CITY PLAN COMMISSION**THURSDAY, MAY 21, 2026****FILE NUMBER:** PLAT-26-000121**SENIOR PLANNER:** Sharmila Shrestha**LOCATION:** Lyndon B. Johnson Freeway/Interstate Highway No. 20, east of S.R.L. Thornton Freeway/Interstate Highway No. 35**DATE FILED:** April 24, 2026**ZONING:** RR**CITY COUNCIL DISTRICT:** 8**SIZE OF REQUEST:** 3.0059-acres**APPLICANT/OWNER:** Dream 84, Inc.**REQUEST:** An application to create one 3.0059-acre lot from tract land in City Block 7591 on property located on Lyndon B. Johnson Freeway/Interstate Highway No. 20, east of S.R.L. Thornton Freeway/Interstate Highway No. 35.**SUBDIVISION HISTORY:**

PRELIMINARY PLAT

OAK CLIFF FARMS UNRECORDED ADDITION

LOT 10 - CITY BLOCK 7591

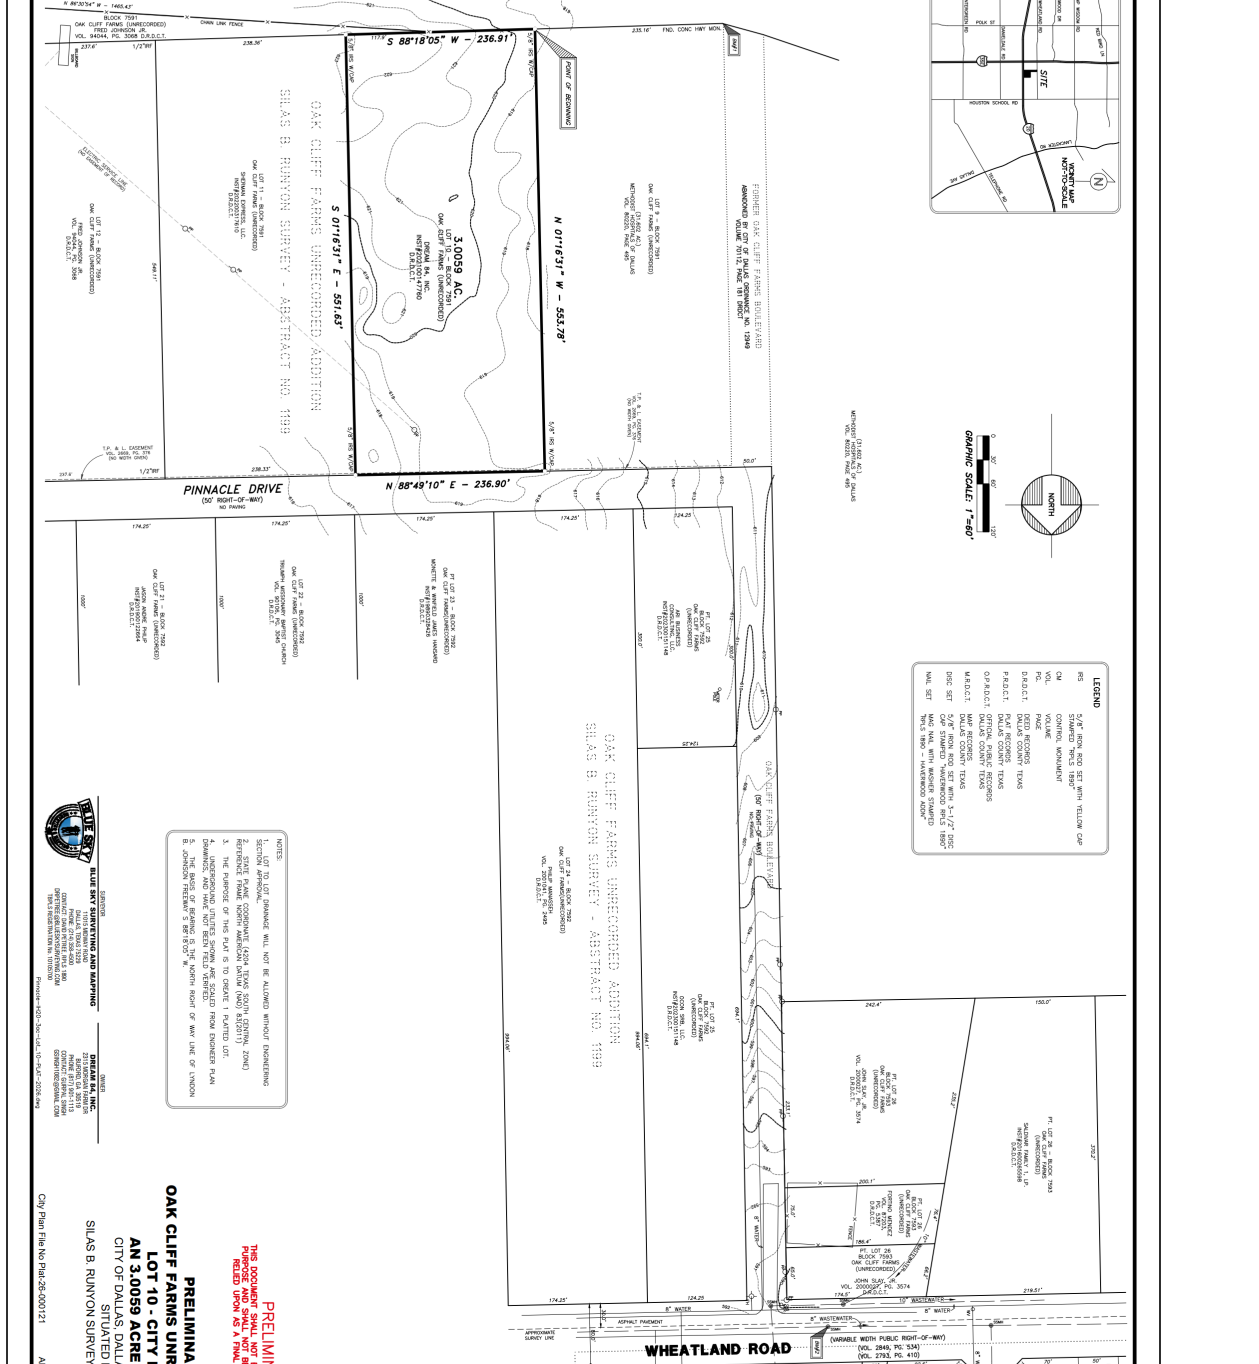
15. On the final plat, dedicate 28 feet of right-of-way (via fee simple or street easement) from the established center line of Pinnacle Drive. Section 51A 8.602(c); 51A 8.604(c)
16. TXDOT approval may be required for any driveway modifications or new access.

17. Prior to final plat, submit a completed final plat checklist and all supporting documents.
18. On the final plat, show how all adjoining right-of-way was created. Section 51A-8.403(a)(1)(A)(xxii).
19. On the final plat, show distances/width across all adjoining right-of-way.
20. Access easement(s) must be recorded by separate instrument(s).

21. On the final plat, show recording information on all existing easements within 150 feet of the property.
22. Need new/different plat name.

25. On the final plat, change “Oak Cliff Farms Boulevard” to “Oak Farms Boulevard.” Section 51A-8.403(a)(1)(A)(xii).
26. On the final plat, change “Pinnacle Drive” to “Pinnacle Drive (FKA Richland Drive).” Section 51A-8.403(a)(1)(A)(xii).
27. On the final plat, change “Wheatland Road” to “Wheatland Road (FKA Duncanville Road).”
28. On the final plat, change “High Harvest Rd” to “High Harvest Road.”
29. On the final plat, change “Arkan Pkwy” to “Arkan Parkway.”
30. On the final plat, change “Lyndon B. Johnson Freeway (Interstate Highway 20) (Interstate Highway 635)” to “Lyndon B. Johnson Freeway/ Interstate Highway No. 20 (FKA Oak Farms Boulevard).”
31. On the final plat, identify the property as Lot 10 in City Block 7591.
